RICKENBACKER AIR NATIONAL GUARD BASE COLUMBUS, OHIO

SITE INSPECTION/REMEDIAL INVESTIGATION/ FEASIBILITY STUDY/REMEDIAL DESIGN

> WORK PLAN FINAL

APPENDIX C - RESPONSE TO COMMENTS OF OHIO EPA ON "DRAFT FINAL" WORK PLAN FOR RICKENBACKER, ANGB, COLUMBUS, OHIO

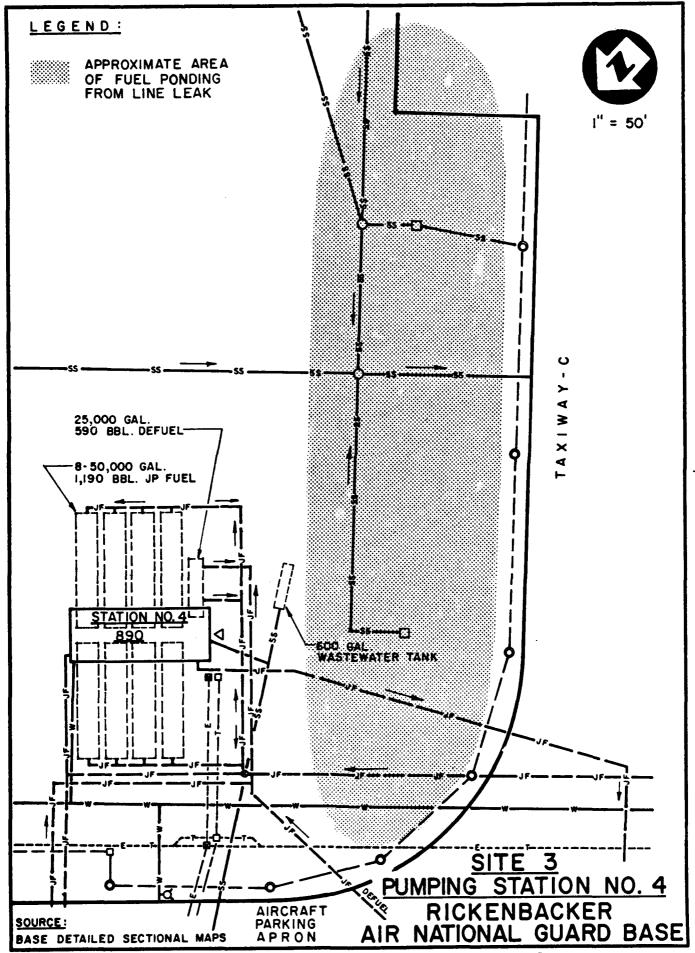
- 4. Page 1-16, Figure 1.7, Site 4 Pumping Station No. 5: According to the description for Site 4 (Page 1-15) there are eight 50,000 gallon underground tanks at this pumping station, however Figure 1.7 shows only four 50,000 gallon underground tanks. Where are the other four 50,000 gallon underground tanks located?

- 5. This figure also does not show where the spill occurred in relation to the pumping station.
 - 6. Page 1-18, Figure 1.9, Site 6 Base Filling Station: From which tank did approximately 100 gallons of unleaded fuel leak in 1985? Where did the line connection rupture? Which of the three storage tanks was determined to be leaking by ANGB personnel?

- 4. There are only four 50,000 gallon tanks at Pumping Station #5, the text has been changed accordingly.
- 5. As described in the text, the spill was a tank overfill. The outline on revised Figure 1.7 surrounds the area of interest for this site.

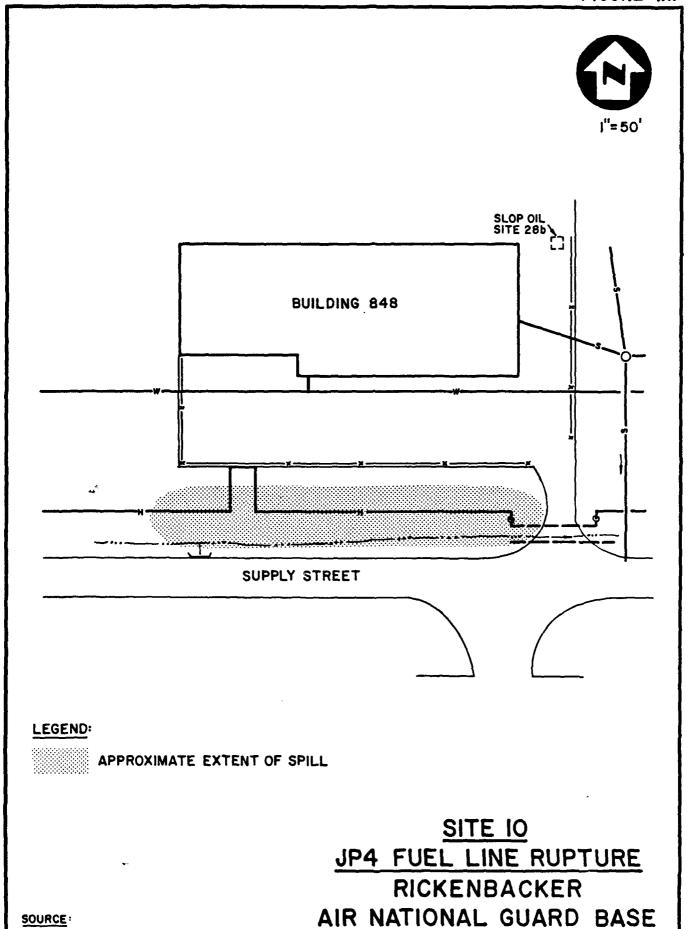
- 8. Page 1-20, Section <u>Site 12: Old Drum Storage Area</u>, Paragraph 2, Sentence 4: There is a typo in this sentence, "onto" should read "into".
 - Page 1-22, Figure 1.12, Site 12 Old Drum Storage Area: Where is the drainage ditch that is adjacent to the paved drum storage area?

- 8. The text has been corrected.
- 9. Revised Figure 1.12 includes the ditch.
- 10. Taxiway F is labeled in the revised figure.
- 11. UV has been changed to Underground Vault and the triangles have been identified as electric transformers in the revised Table 1.2

SITES 14 & 16 KC-135 CRASH SITE AND NORTHEAST FUEL DUMP PIT RICKENBACKER AIR NATIONAL GUARD BASE

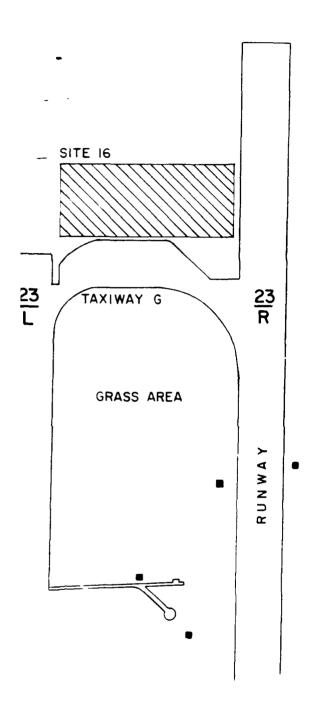
- /C, Page 1-23, Figure 1.13, Site 14 and 16 KC-135 Crash Site and Northeast Fuel <u>Dump Pit</u>: According to the description for Site 14 (Page 1-20) the crash took placed on Taxiway F, however this taxiway is not shown on Figure 1.13. Taxiway F should be labeled as such on this figure.

NORTH COAL PILE AND
LUBE OIL DRUM STORAGE
RICKENBACKER
AIR NATIONAL GUARD BASE

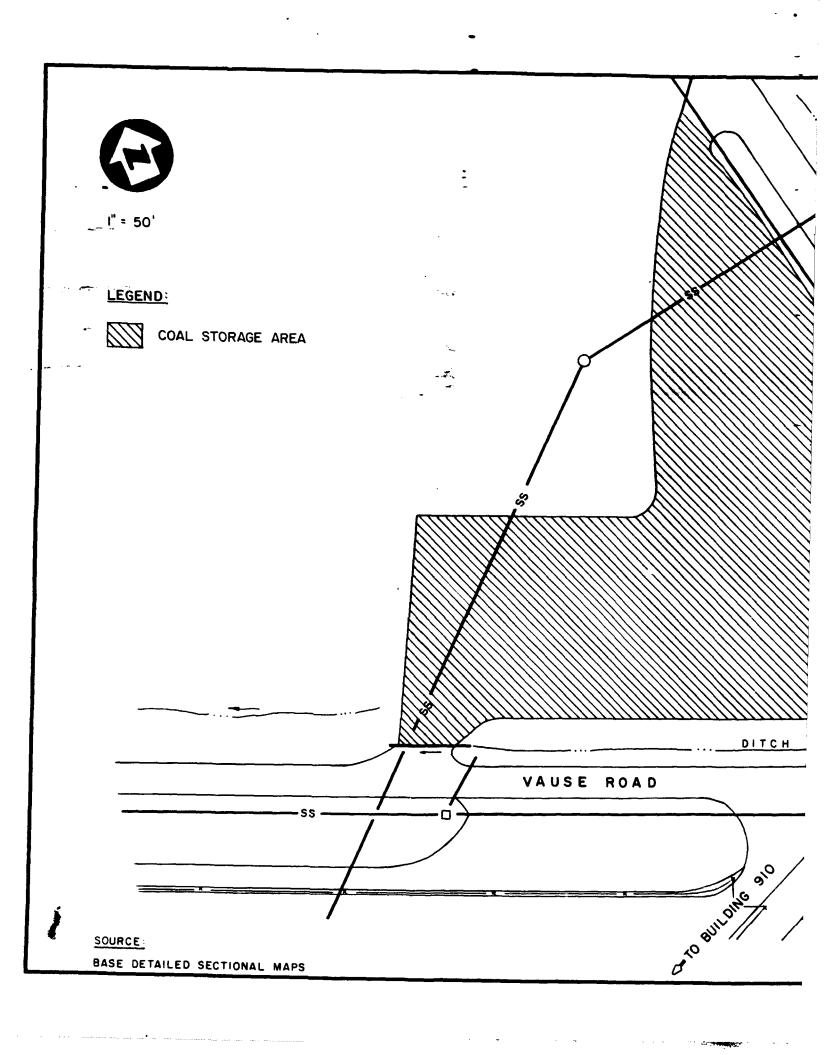
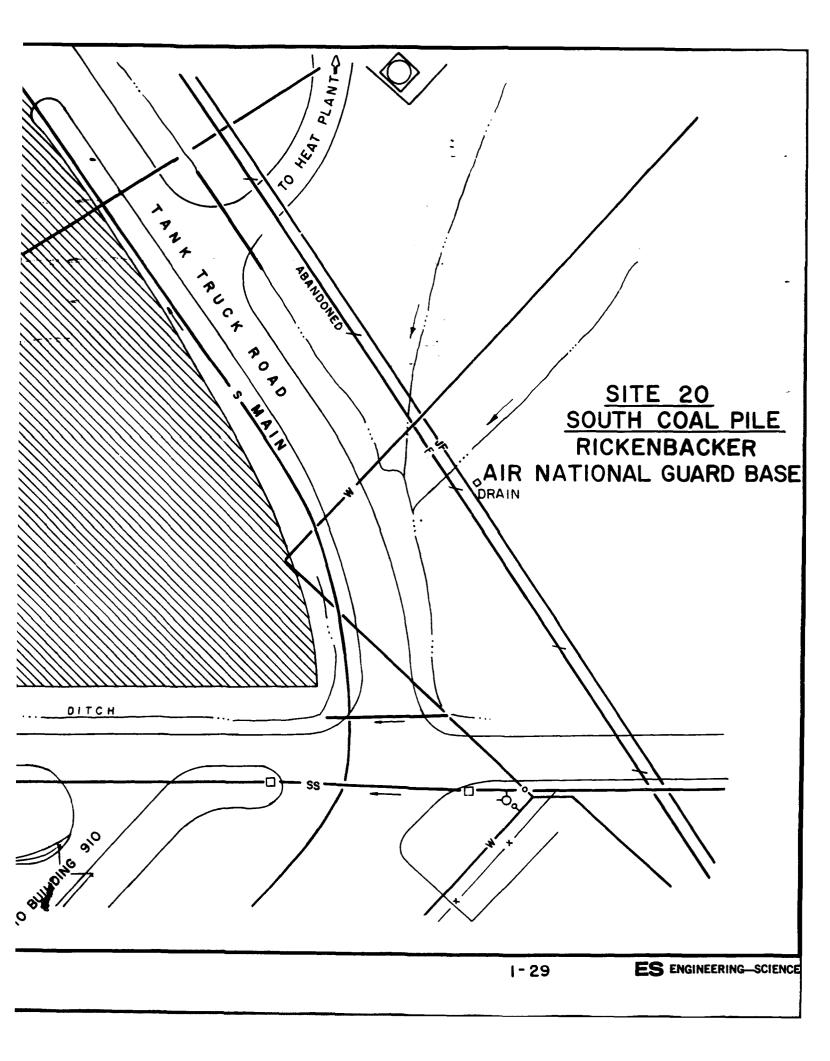
- //, Page 1-26, Figure 1.15, Sites 19 and 22 North Coal Pile and Lube Oil Drum Storage: What do the initials UV stand for? What do the triangles stand for? Figure 1.15 needs a legend to identify the symbols that are not addressed by table 1.2 (Page 1-10).

OLD ENTOMOLOGY LAB

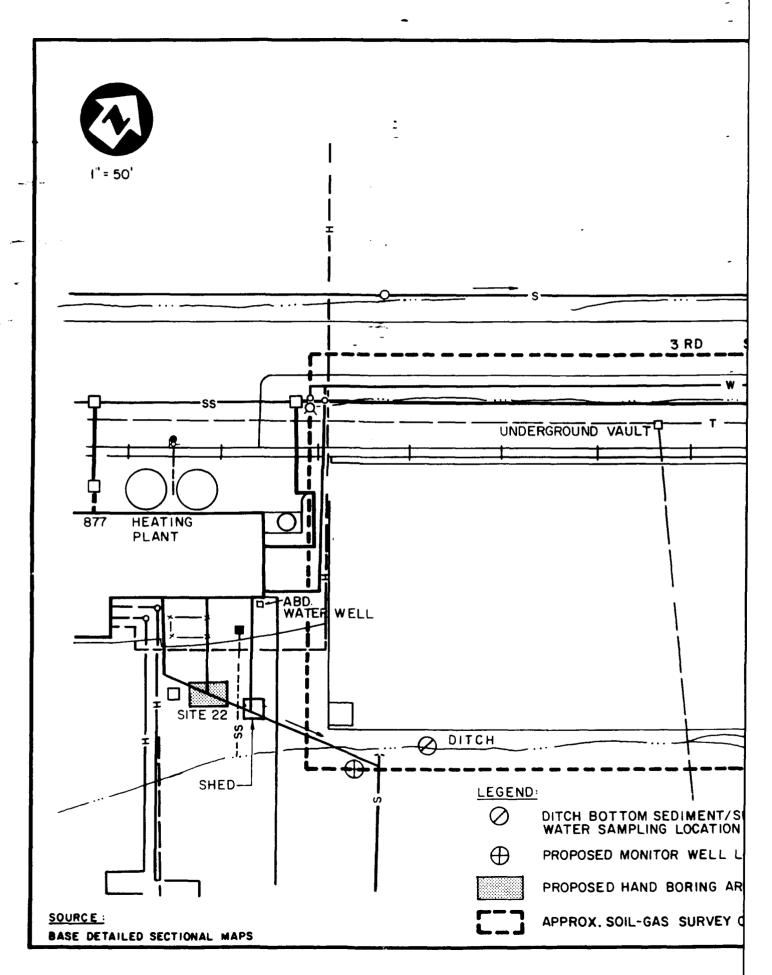
- Page 3-25, Figure 3.12, <u>Site 17 Old Entomology Laboratory</u>: According to the description of Site 17 (Page 3-24) eight hand borings will be collected around the exterior of the end of the building where the laboratory was located, however only seven hand borings are shown on Figure 3.12. Where will the eighth boring be located?

SITES 19 AND 22

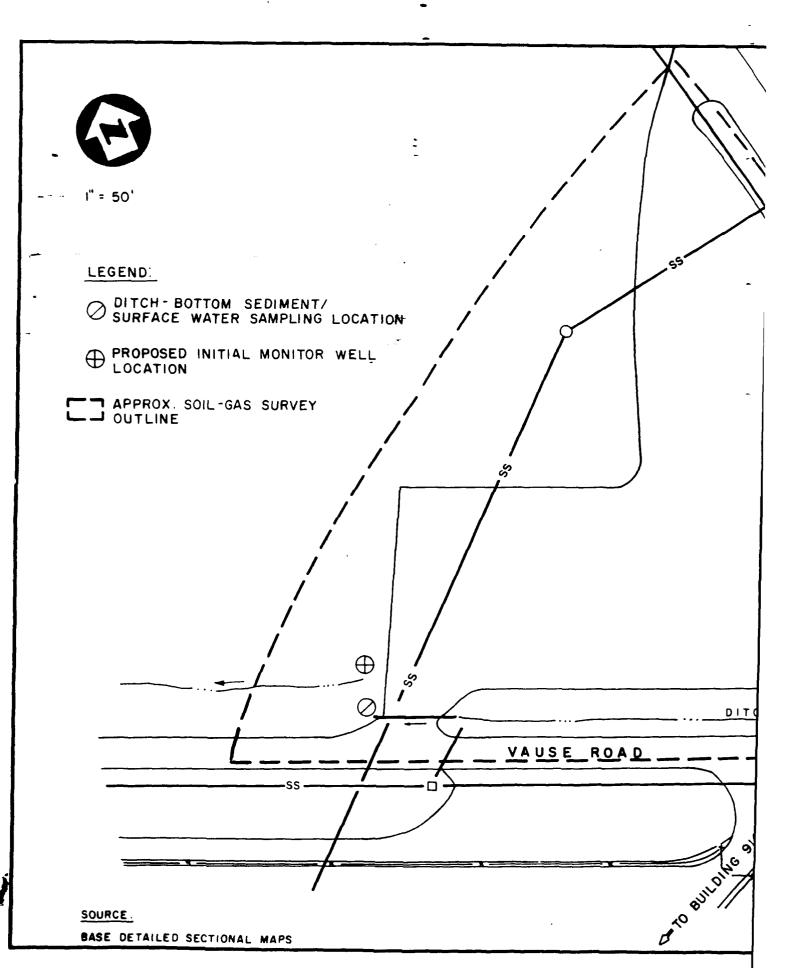
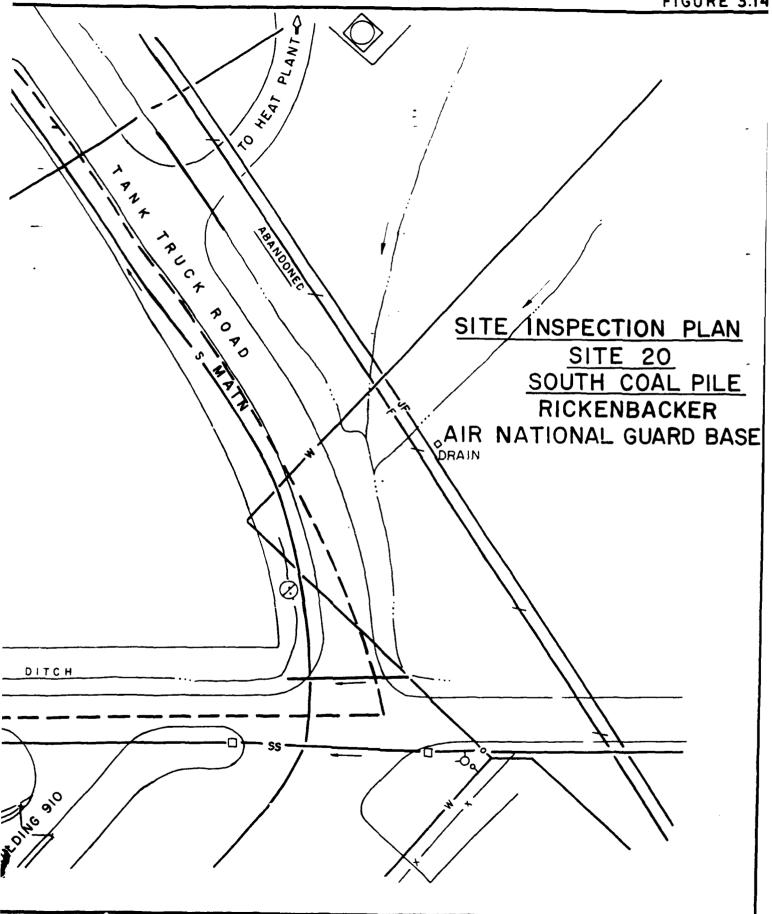
- Pages 3-26 and 3-27, Figures 3.13 and 3.14, Sites 19 and 22 North Coal Pile and Lube 011 Drum Storage and Site 20 South Coal Pile: Table 3.1 indicates that three ditch bottom samples will be collected from Sites 19 and 20, however Figures 3.13 and 3.14 show that a combined total of four samples will be collected.
